2. AMENDMENT/MODIFICATION NO. 0002		3. EFFECTIVE DATE 03-Feb-2006		4. REQUISITION/PURCHASE REQ. NO.		5. PROJECT NO.(If applicable)	
6. ISSUED BY USACE, CONTRACTING DIVISION ATTN: CEMVN-CT, ROOM 172 7400 LEAKE AVE. NEW ORLEANS LA 70118-3651		CODE W912P8		7. ADMINISTERED BY (If other than item 6) <div style="text-align: center; font-weight: bold;">See Item 6</div>		CODE

14. DESCRIPTION OF AMENDMENT/MODIFICATION (Organized by UCF section headings, including solicitation/contract subject matter where feasible.) The above numbered solicitation for New Orleans To Venice Hurricane Protection Project, Buras Levee District, West Bank River Levee, Emergency Levee Repairs, Contract P13 - B/L Sta. 232+00 to B/L Sta. 285+00, Plaquemines Parish, LA, is amended as shown on the attached pages. A PROPOSAL DUE DATE OF 7 FEBRUARY 2006, 9:00 AM LOCAL TIME, NEW ORLEANS, LA, IS ESTABLISHED.							
Except as provided herein, all terms and conditions of the document referenced in Item 9A or 10A, as heretofore changed, remains unchanged and in full force and effect.							
15A. NAME AND TITLE OF SIGNER (Type or print)				16A. NAME AND TITLE OF CONTRACTING OFFICER (Type or print)			
				TEL: _____ EMAIL: _

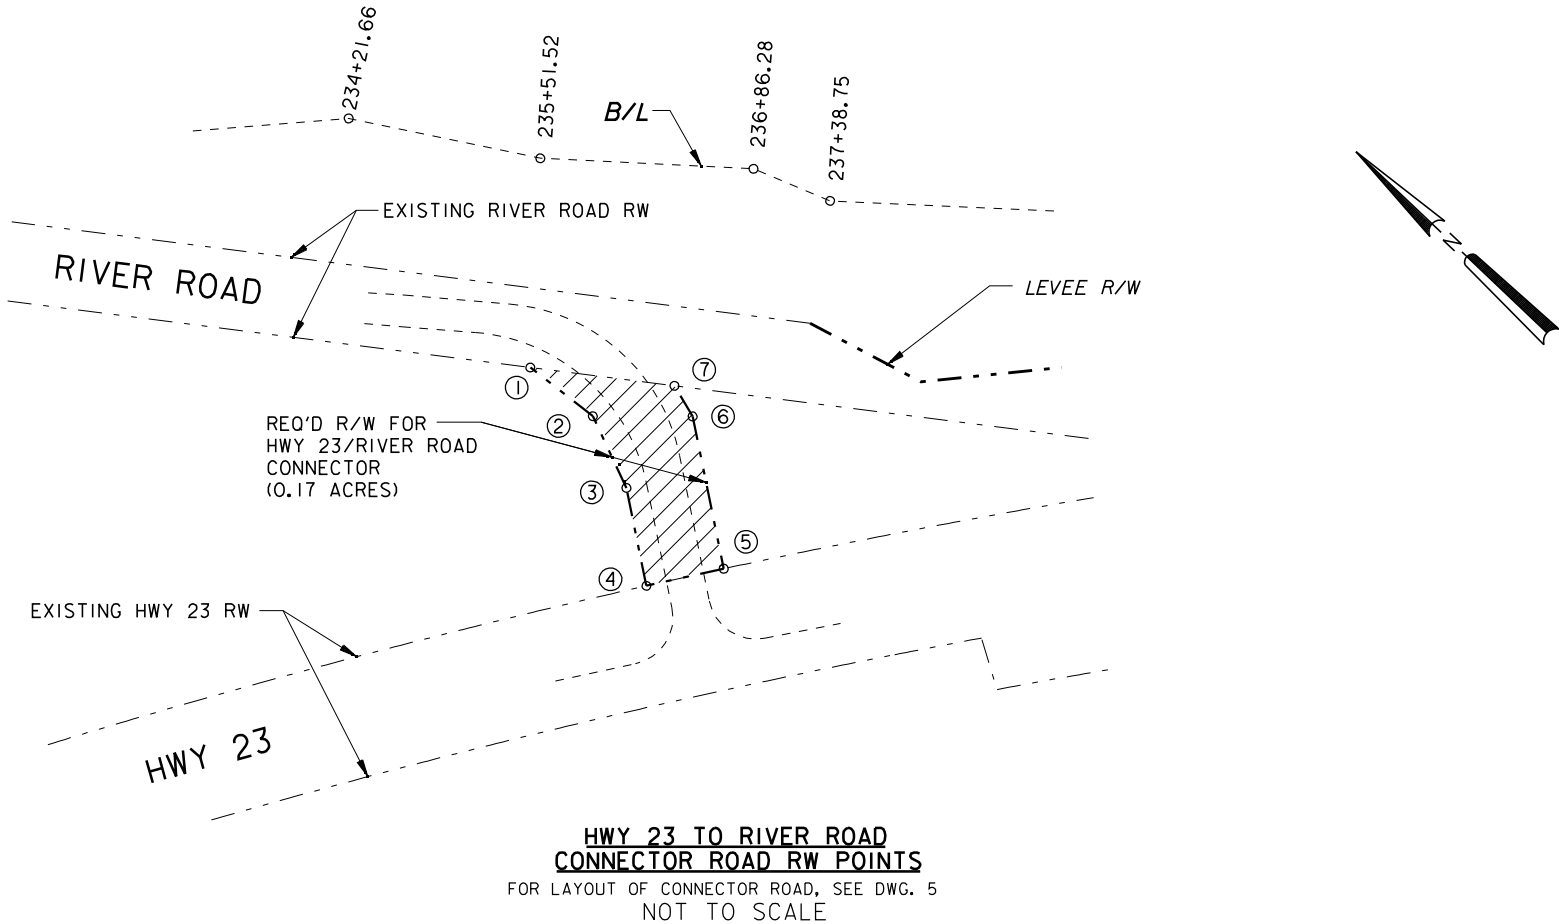
△ TABULATION OF LEVEE R/W		
B/L STATION	OFFSET	AZIMUTH
232+10.9	48.12'	*
235+41.62	61.75'	*
237+38.75	78.30'	236°38'28"
238+01.14	111.63'	*
238+89.56	98.37'	*
239+37.07	90.61'	216°10'52"
240+56	52.49'	*
241+89.65	47.44'	*
248+61.73	127.99'	*
249+10.26	126.80'	*
250+50.90	125.57'	*
252+91.12	127.29'	*
253+98.31	128.60'	*
255+79.10	123.75'	*
261+97.36	134.26'	*
266+54.37	126.00'	*
273+36.24	136.61'	*
275+71.33	111.64'	*

△	REVISED TABLE OF LEVEE R/W.	2/3/06	E.J.P.
SYMBOL	DESCRIPTION	DATE	APPROVED
REVISIONS			
NEW ORLEANS TO VENICE HURRICANE PROTECTION PROJECT BURAS LEVEE DISTRICT WEST BANK RIVER LEVEE EMERGENCY LEVEE REPAIRS CONTRACT P13			
TABULATION OF OFFSETS B/L STA. 232+00 TO B/L STA. 285+00 PLAQUEMINES PARISH, LA			
U.S. ARMY ENGINEER DISTRICT, NEW ORLEANS CORPS OF ENGINEERS NEW ORLEANS, LOUISIANA			
DESIGNED BY: P.S.L.	PLOT SCALE: 200	PLOT DATE: 01/20/06	CADD FILE: CONTP13-06a-TAB
DRAWN BY: C.G.H.			FILE NO.
CHECKED BY: C.J.R.	DATE: JAN 2006		H-8-XXXXX
